LOCAL REVIEW BODY

EAST RENFREWSHIRE COUNCILLOCAL REVIEW BODY10 August 2022Report by Director of Business Operations and PartnershipsREVIEW OF CASE - REVIEW/2022/04**SUBDIVISION OF EXISTING PLOT AND ERECTION OF TWO STOREY
DWELLINGHOUSE.****PURPOSE OF REPORT**

2. Application type: Full Planning Permission (Ref No:- 2021/0220/TP).
- Applicant: Mr Malcolm Cameron
- Proposal: Subdivision of existing plot and erection of two storey dwellinghouse.
- Location: Pine Lodge, 35 Greenlaw Road, Newton Mearns, East Renfrewshire, G77 6SL.
- Council Area/Ward: Newton Mearns North And Neilston (Ward 2).

Rear Garden and Patio – 2012

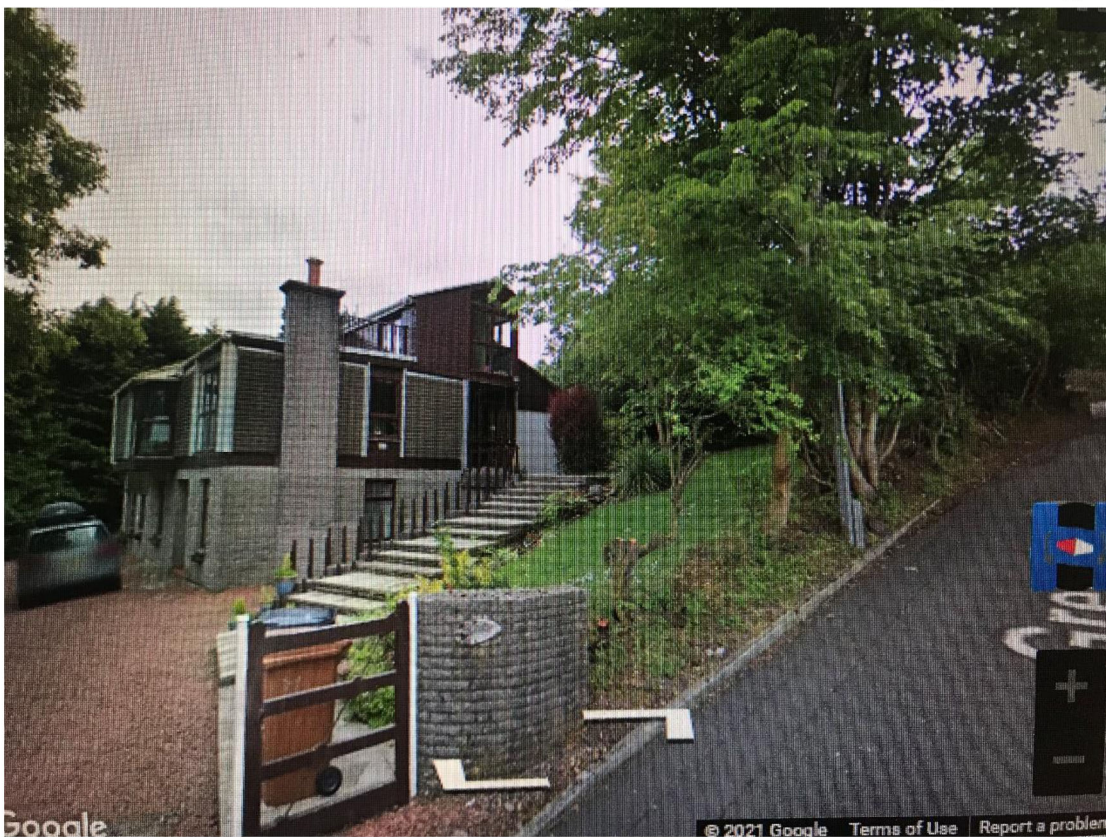
This statement does not justify abandoning the rear garden. The views to the West can be clearly seen from the area of the rear garden which extends out beyond the side of the house to the North. There is also a patio area which is shown on Drawing AP (0)001 and which extends out to the side of the house at the level of the rear garden from which the views can be enjoyed.

The occupants of 35 Greenlaw Road now wish to sell off the area of garden at the rear of the house which is south facing, has a large decked patio area and is adjacent to and on the same level as the main living area. This proposal will clearly have a significantly detrimental impact on the existing property. It will remove forever any opportunity for future occupants of the site to utilise it as it was originally planned and in particular -

PLANNING		
Client MR & MRS CAMERON		
Project Title PROPOSED NEW HOUSE 35 GREENLAW DRIVE NEWTON MEARNS		
Drawing Title EXISTING SITE & LOCATION PLAN		
Scale 1: 200 & 1250	Date 16/12/20	
Drawn by GS	Checked by GS	
Job No. 20010	Drawing No. AP(0)001	Rev.

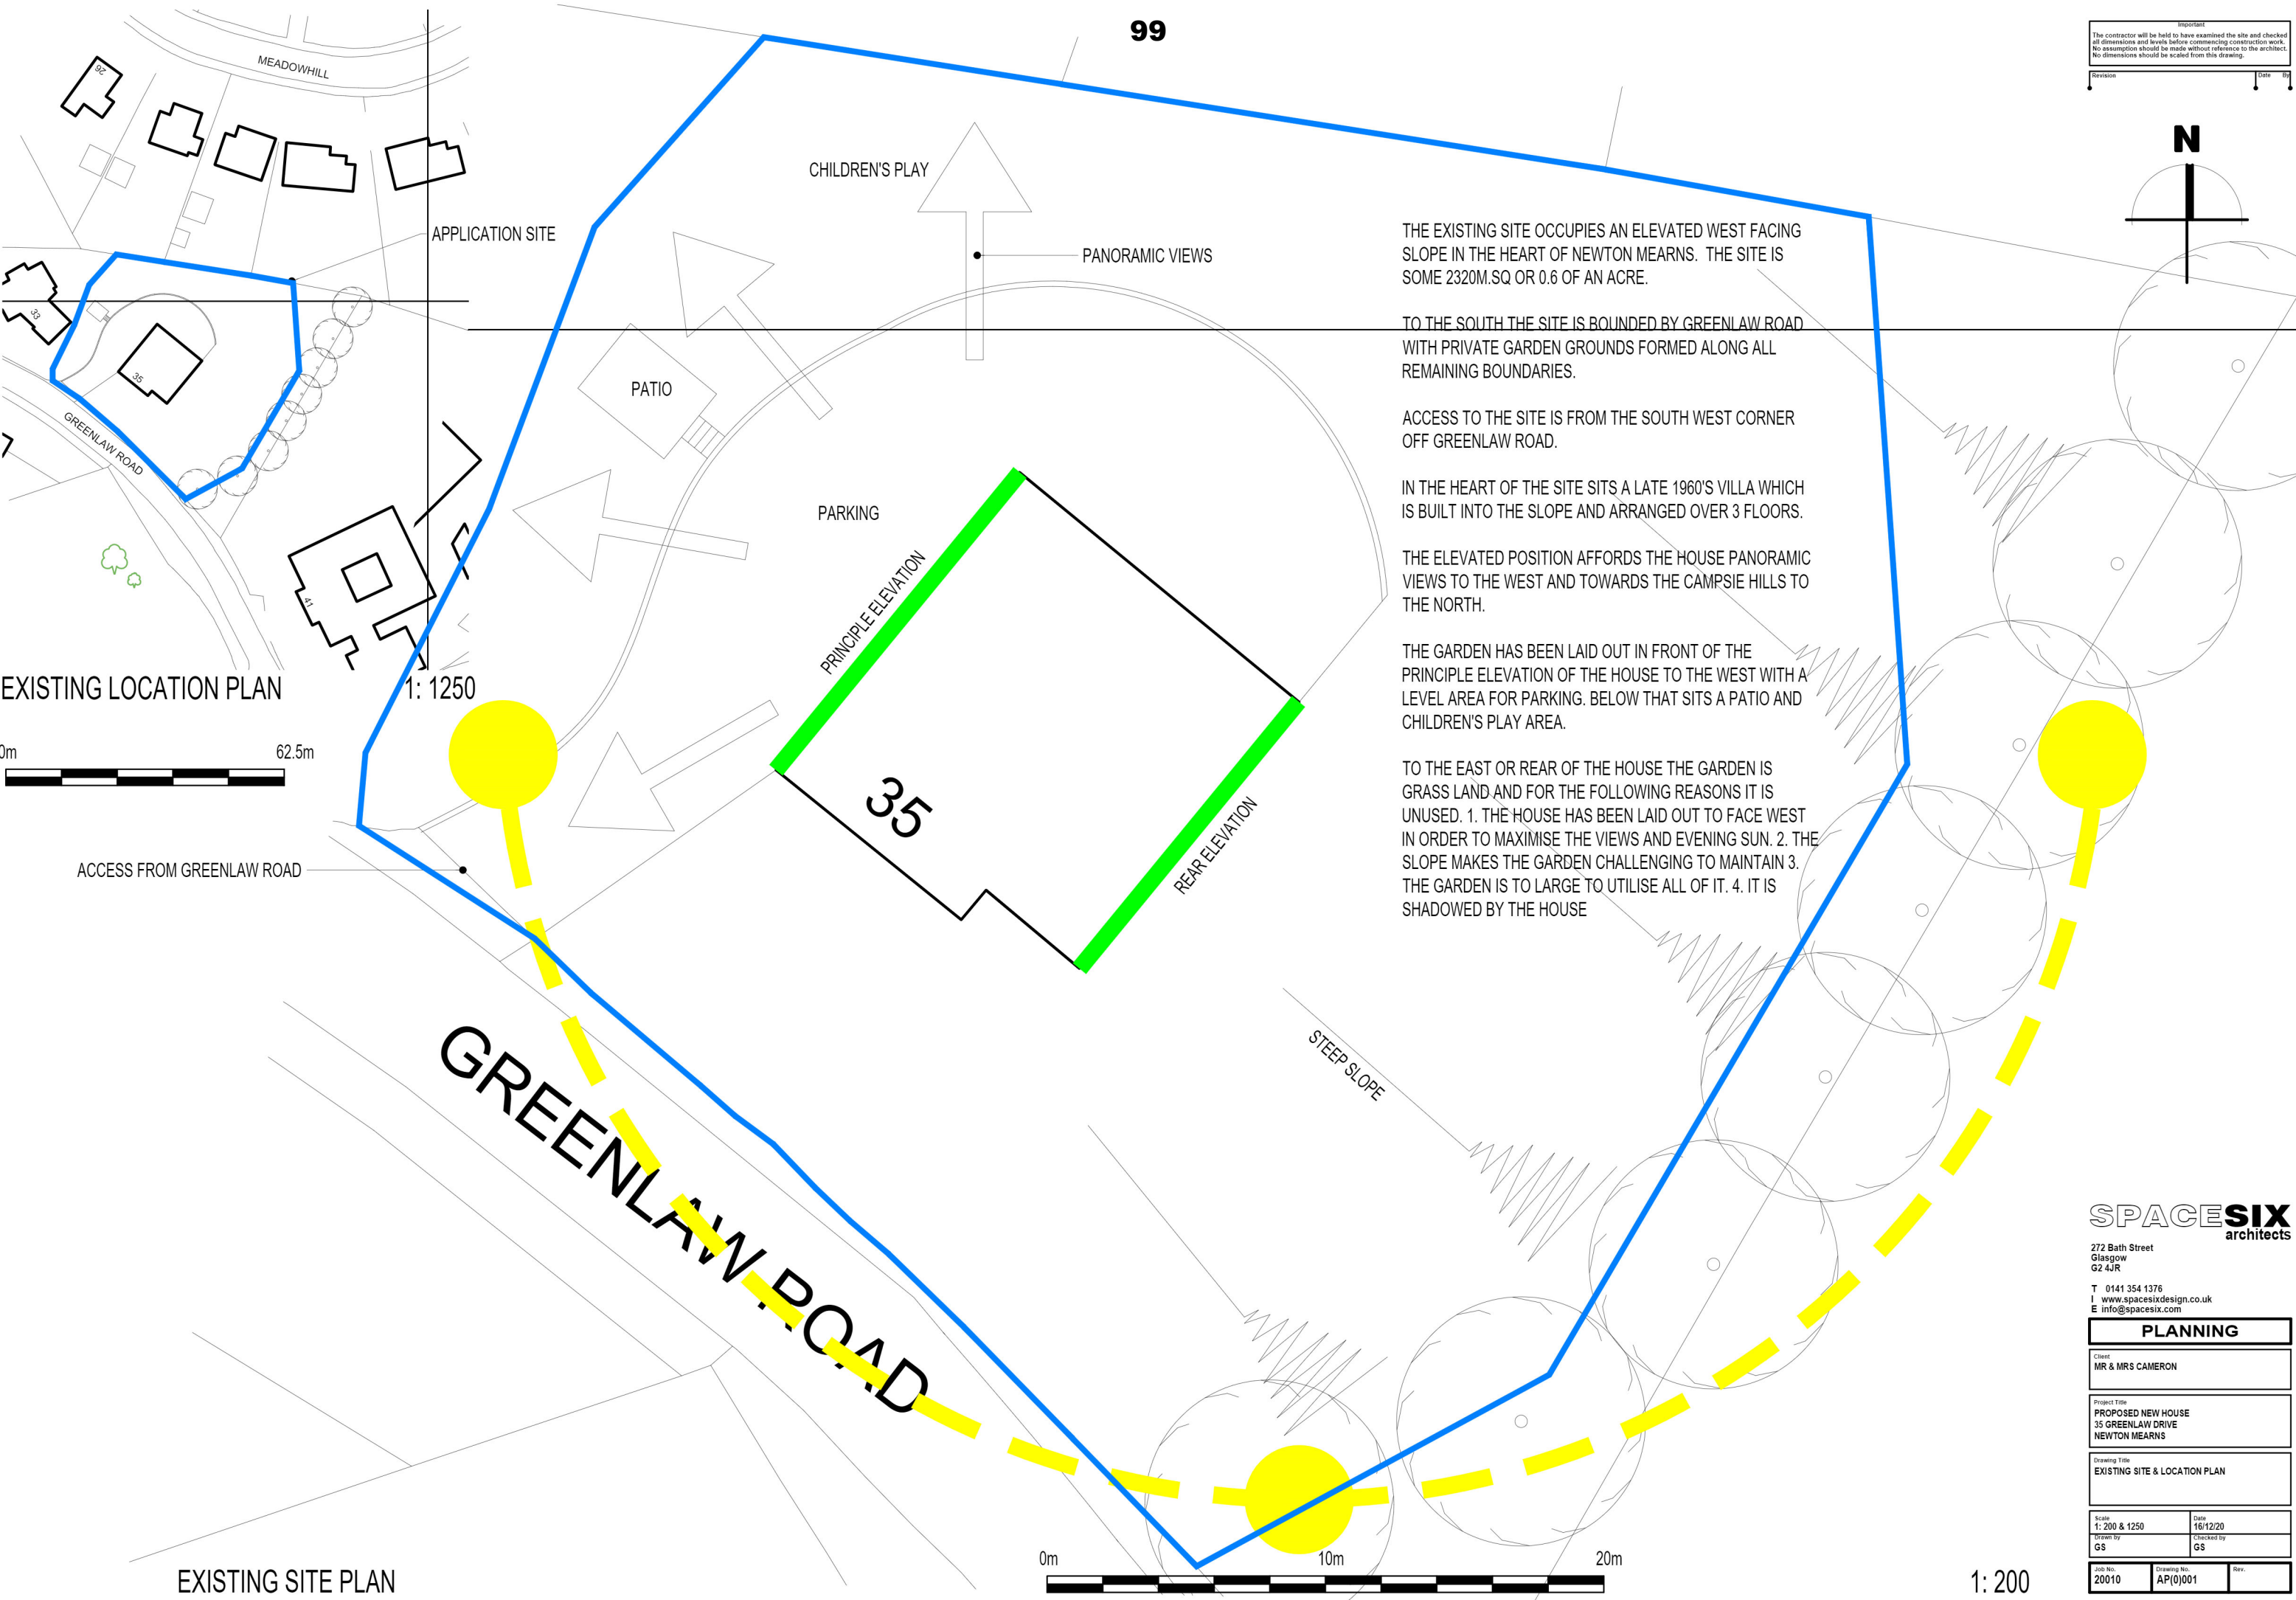
Given that 2021/0220/TP is a separate application we have attached our letter of objection to 2021/0031/TP as an Appendix to this letter. It is worth highlighting again that a number of the statements made in support of Planning Application 2021/0031/TP on Existing Location Plan Drawing AP (0)001 are factually incorrect –

We note that the current planning application is justified on the basis of a number of issues set out on the Existing Location Plan Drawing AP (0)001:
